**APPLICATION FOR PERMISSION
UNDER SECTION 16 OF
THE TOWN PLANNING ORDINANCE
(CAP.131)**

For Official Use Only 請勿填寫此欄	Application No. 申請編號	A/7C KTN/836
	Date Received 收到日期	10 MAY 2022

(b) Intended use/development 有意進行的用途/發展 <p>擬議臨時動物寄養所 (為期5年)及填土工程 Proposed Temporary Animal Boarding Establishment for a period of 5 years and Filling of Land</p>

有關城市規劃委員會對 A/YL-KTN/836 的查詢

Location of Septic Tank and Soakaway System

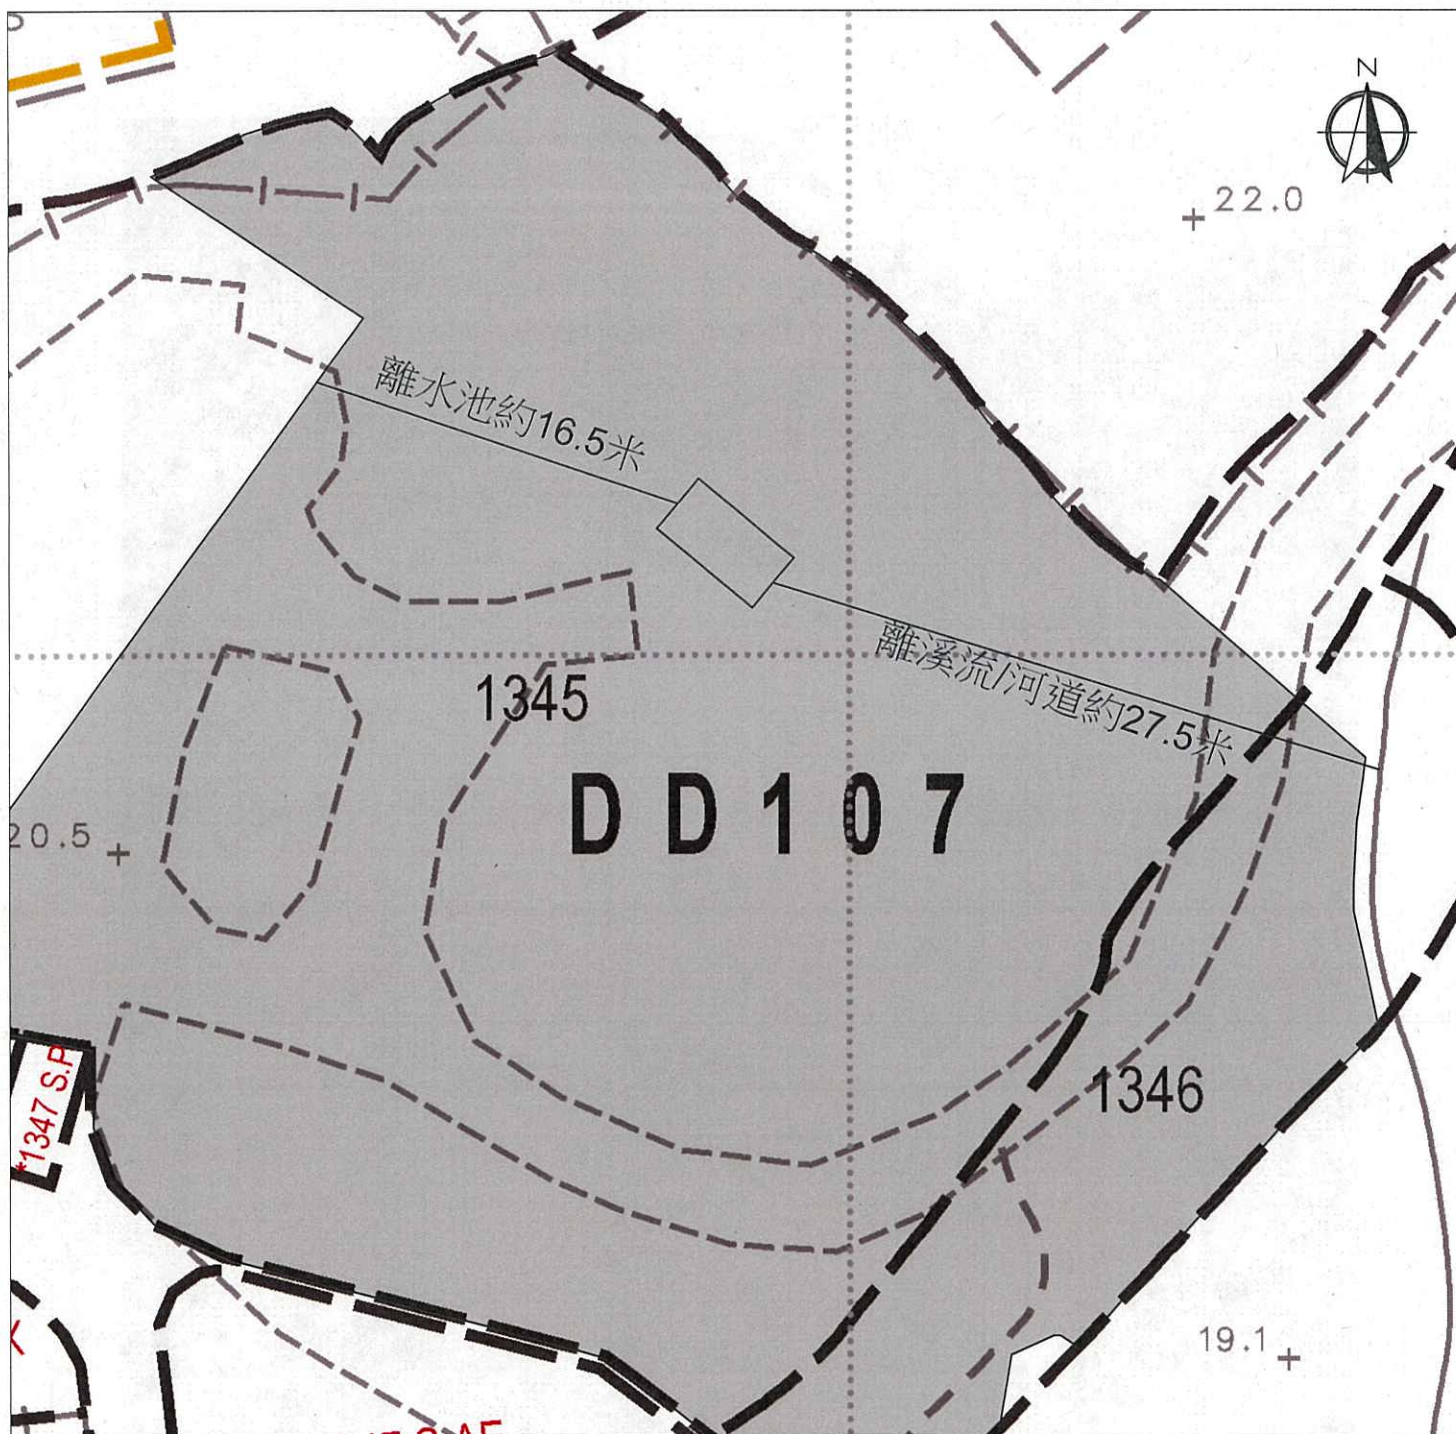
有關環境保護署對 A/YL-KTN/836 的查詢

此外，本人已在申請地點建造了一個符合環境保護署所定下的 ProPECC PN 5/93 指引的化糞池來收集寄養所內的污水。化糞池及滲水井的距離更會遠離水池及河道超過 15 米，由於申請地點附近的水池及溪流/河道不是用作飲用用途，此距離亦符合環境保護署所定下的 ProPECC PN 5/93 指引，化糞池及滲水井與水池及溪流/河道的大約距離請參考 Appendix 1。有關化糞池及滲水井亦不會連接雨水渠，務求對附近的污染降至零污染，確保附近的水源及土地不會被此申請用途污染，嚴格執行漁農自然護理署及渠務署的要求。

Proposed Fire Service Installation Plan

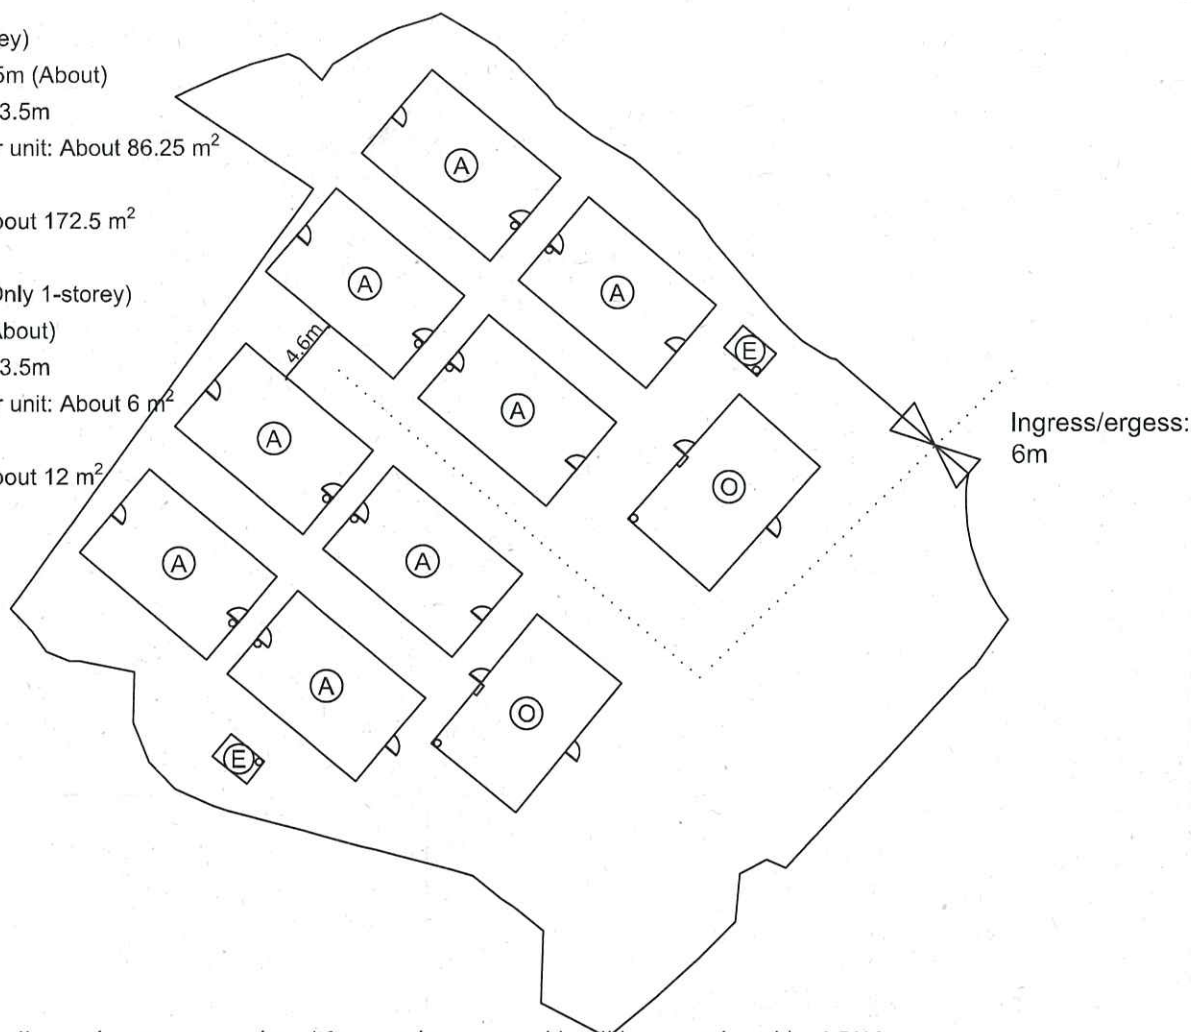
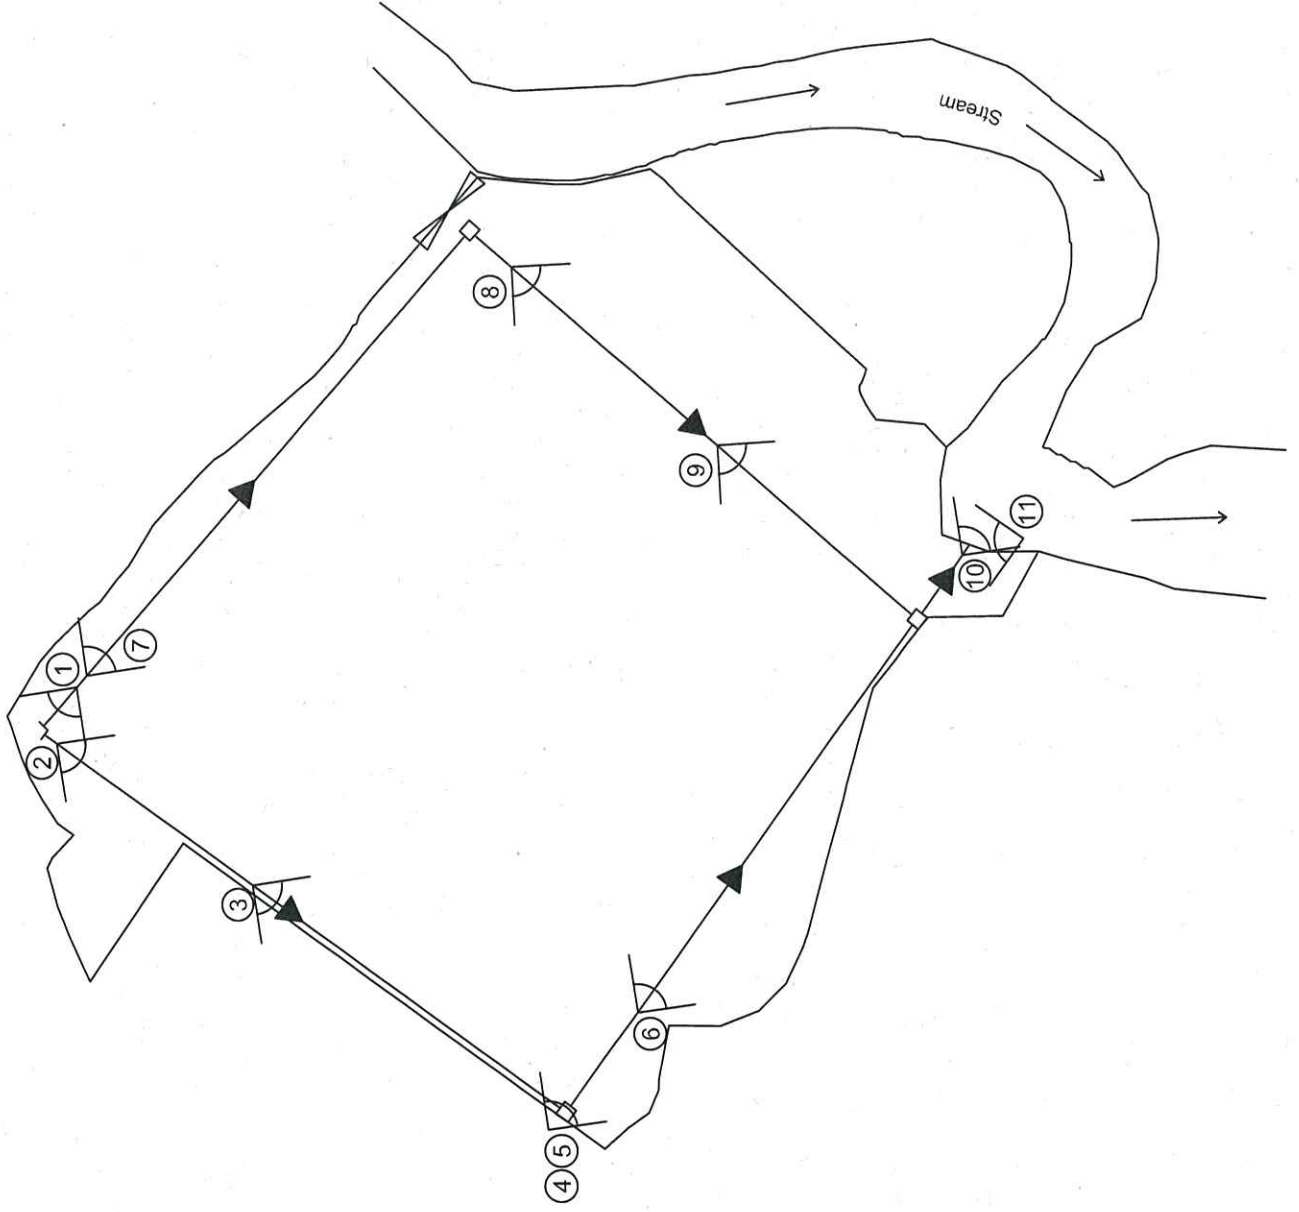
- no in-principle objection to the application subject to FSIs being provided to his satisfaction;
- based on the FI submitted (**Appendix Ia**), the FSIs proposal is considered acceptable. Should the application be approved, an approval condition requiring implementation of FSIs proposal to his satisfaction or of the Board should be included; and
- the applicant is reminded that if the proposed structure(s) is required to comply with the Buildings Ordinance (Cap. 123), detailed fire service requirements will be formulated upon receipt of formal submission of general building plans.

*All FSI (includes installation/maintenance/modification/repair work) will be completed by RFSIC.

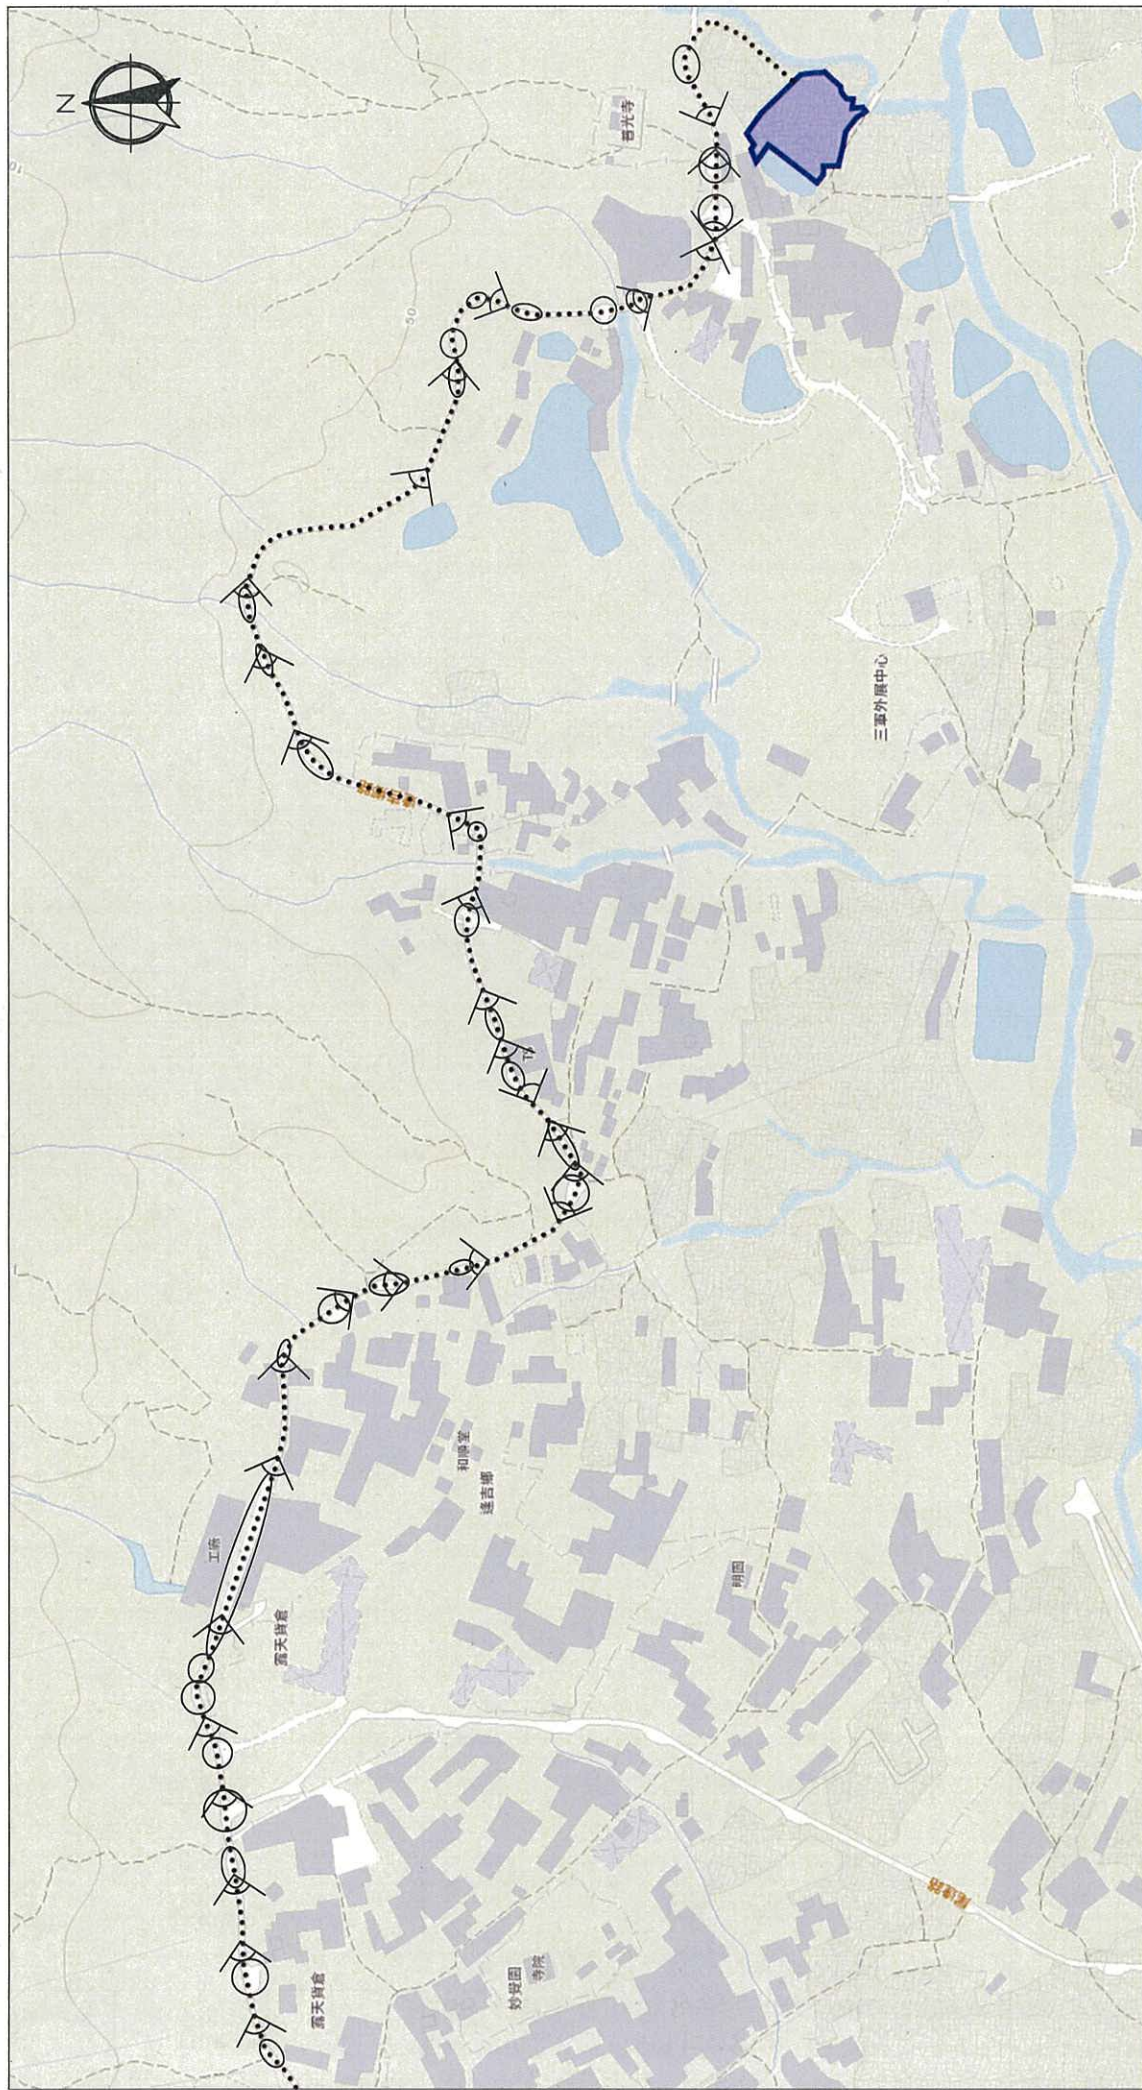
有關對運輸署 A/YL-KTN/836 的查詢

申請地點有道路連接，前往本申請地點途經逢吉鄉路，再轉入小徑前行大約 50 米到達申請地點的大門。沿途道路至少有 3 米闊，最多約有 6 米闊，直達申請地點，沿途也有避車處，客貨車有足夠的位置通過。沿途道路相片請參考文件末端，而相片的觀看點請參考 Appendix 6。
